APPLICATION NOTE

ZHL-42+ PCN Report

AN-60-071

CASE STYLE

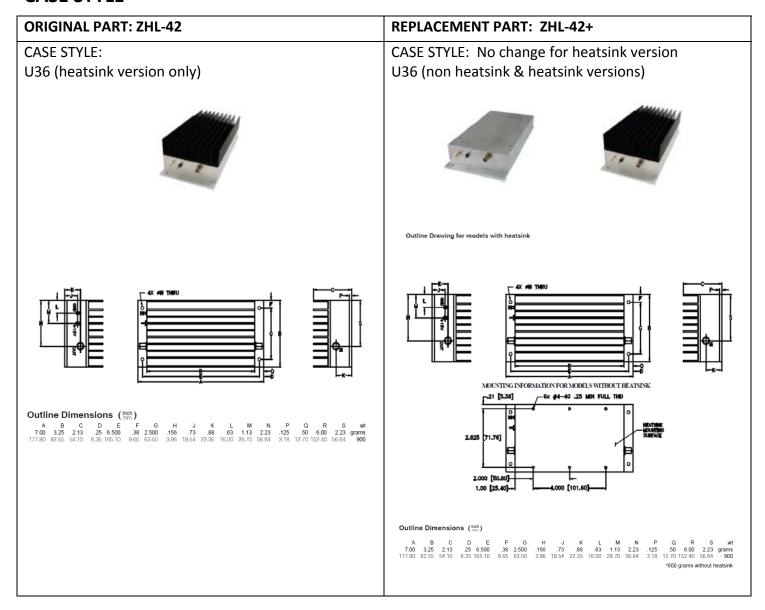
As a result of the introduction of a RoHS compliant version (+), non heatsink version, and assembly option at an alternate qualified Mini-Circuits facility, the replacement part has been judged by the Mini-Circuits Engineering team as a suitable replacement for the existing $ZHL-42_a$.

1) FIT and FORM are compatible with minor change: Create non heatsink version

COMPARISON PERFORMANCE CURVESa: T_{AMB}=25°C

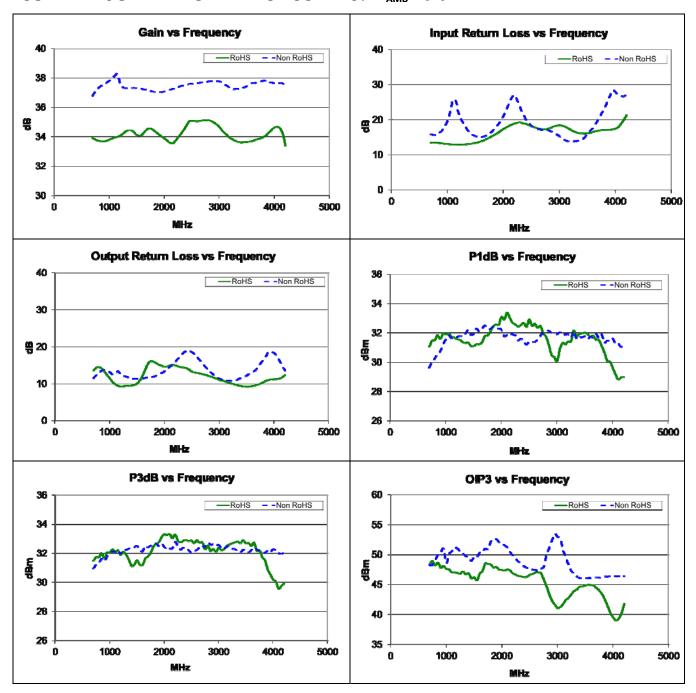
2) Functional changes as follows:

Parameter	Original Part, ZHL-42	Replacement Part, ZHL-42+	
Gain Flatness	+/-1dB max	+/-1.3dB max, +/-0.8dB typ	
P1dB	28dBm min	28dBm min*, 30dBm typ	
		*27dBm at 3700-4200MHz	
P3dB	N/A	29dBm min**, 31dBm typ	
		**28dBm at 3700-4200MHz	
Noise Figure	10dB typ	8dB typ	
Supply Current	0.88A max	1A max
